Flight Procedure Tracking Form		Action: FLIGHT CHECK	Task Type: IAP	Date Open: 12/26/2018	Task #: 2015080411442901009	Request #: 20150804114429
Procedure: RNAV (GPS) RWY 14L AMDT 1			Airport ID: KNUQ	Airport: MOFFETT FEDERAL AFLD		Reimbursable #: NO
City: MOUNTAIN VIEW	ST: CA	GPS #:	Estimated Chart Date: 06/20/2019		FICO #:	
Fac ID: N/A		Fac. Type:			Specialist: MIKE MELSEN	
Procedure Review						
	Rec'd	Rel'd	Full Name	Comments		
Lead:	12/21/2018			<i>Digitally signed by</i>		
QA:				WARDELL HENNING		
Liaison:				Mar 28, 2019		
Procedure Comments:			ENROUTE-NON	Remark Type: INFORMATION		
CONTACT: ANDREW HENNING; AJV-A43 LEAD; 405.954.9954.

RNAV (GPS) RWY 14L

MOFFETT FEDERAL AFLD (NUQ)

**AMENDMENTS TO MULTIPLE PROCEDURES
RNAV (GPS) RUNWAY 32R, ORIGINAL**

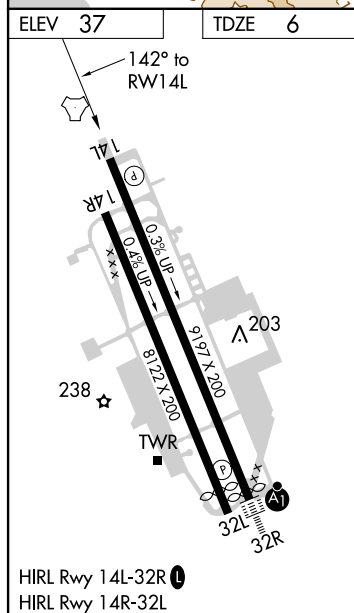
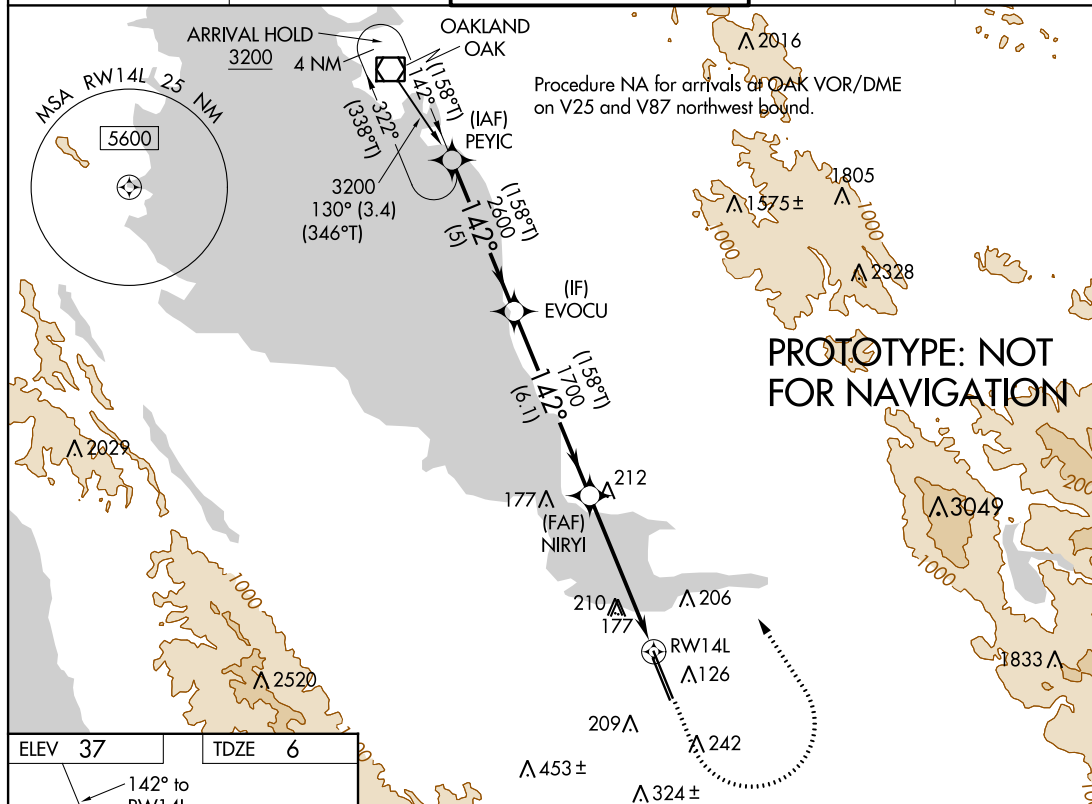
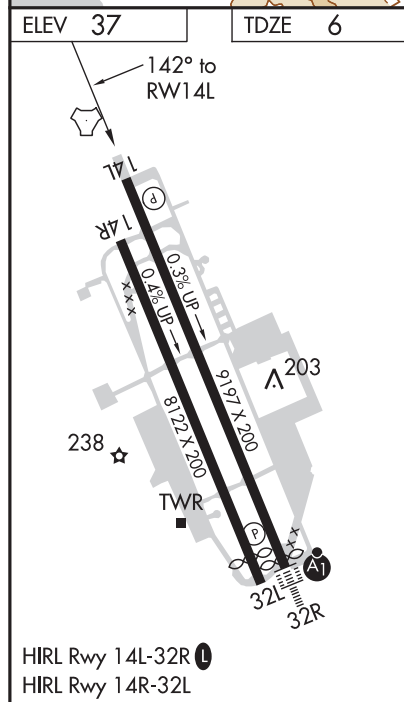
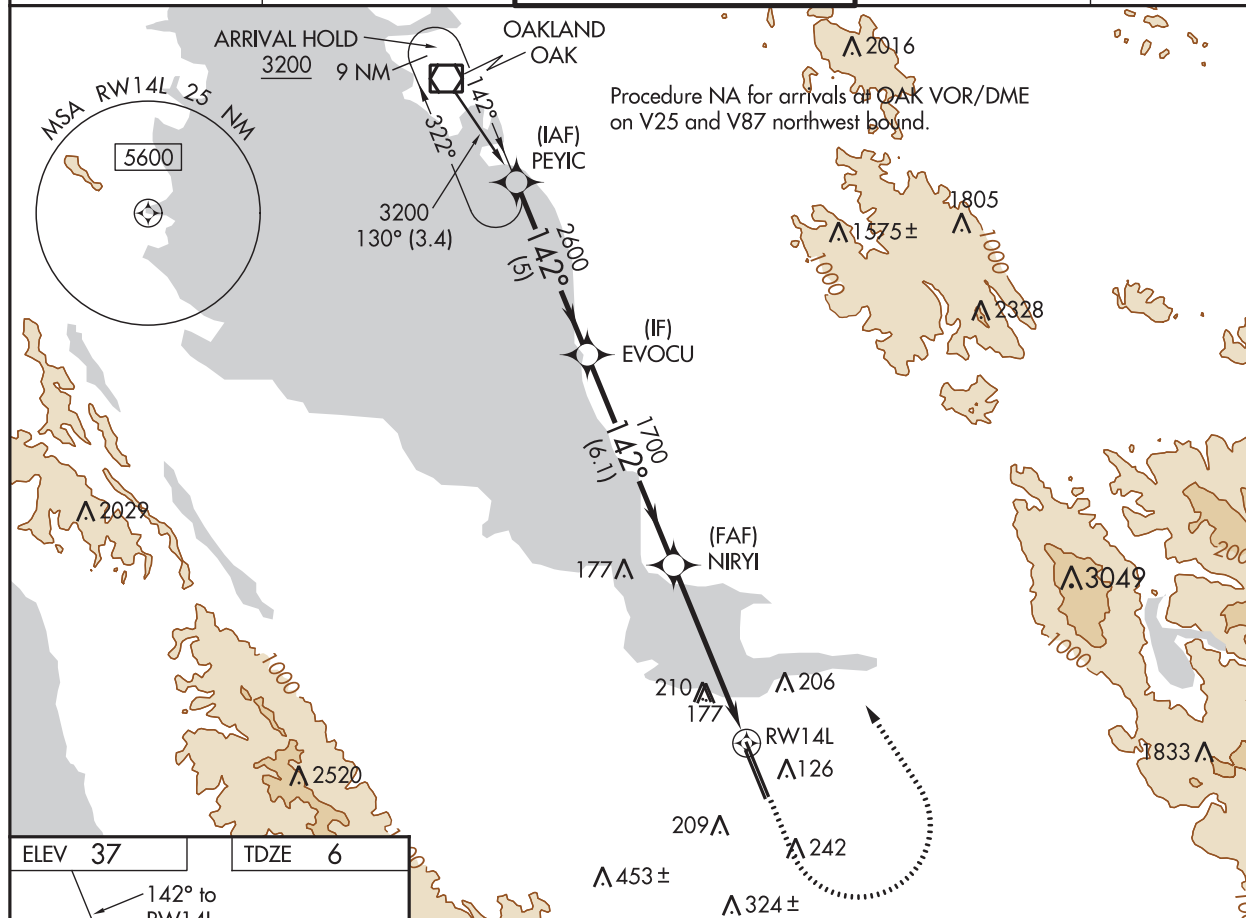
<p>PEYIC 3200 (158°T) 142° EVOCU 2600 NIRYI 1700 1700 *1.1 NM to RW14L *LNAV only RW14L</p> <p>GP 3.00° TCH 53</p> <p>5 NM 6.1 NM 4.1 NM 1.1 NM</p>				
CATEGORY	A	B	C	D
LPV DA	256-¾ 250 (300-¾)			
LNAV/VNAV DA	326-⅞ 320 (400-⅞)			
LNAV MDA	440-1 434 (500-1)		440-1¼ 434 (500-1¼)	
CIRCLING	540-1 503 (600-1)	600-1 563 (600-1)	620-1½ 583 (600-1½)	780-2¼ 743 (800-2¼)

PEYIC	EVOCU	NIRYI	
	3200	2600	1700	
	GP 3.00° TCH 53			
	5 NM	6.1 NM	4.1 NM	1.1 NM
CATEGORY	A	B	C	D
LPV DA	255-3/4 250 (300-3/4)			
LNAV/VNAV DA	391-1 386 (400-1 1/8)			
LNAV MDA	440-1 435 (500-1)		440-1 435 (500-1 1/4)	
▲ CIRCLING	540-1 503 (600-1)	600-1 563 (600-1)	620-1 1/2 583 (600-1 1/2)	720-2 1/4 683 (700-2 1/4)
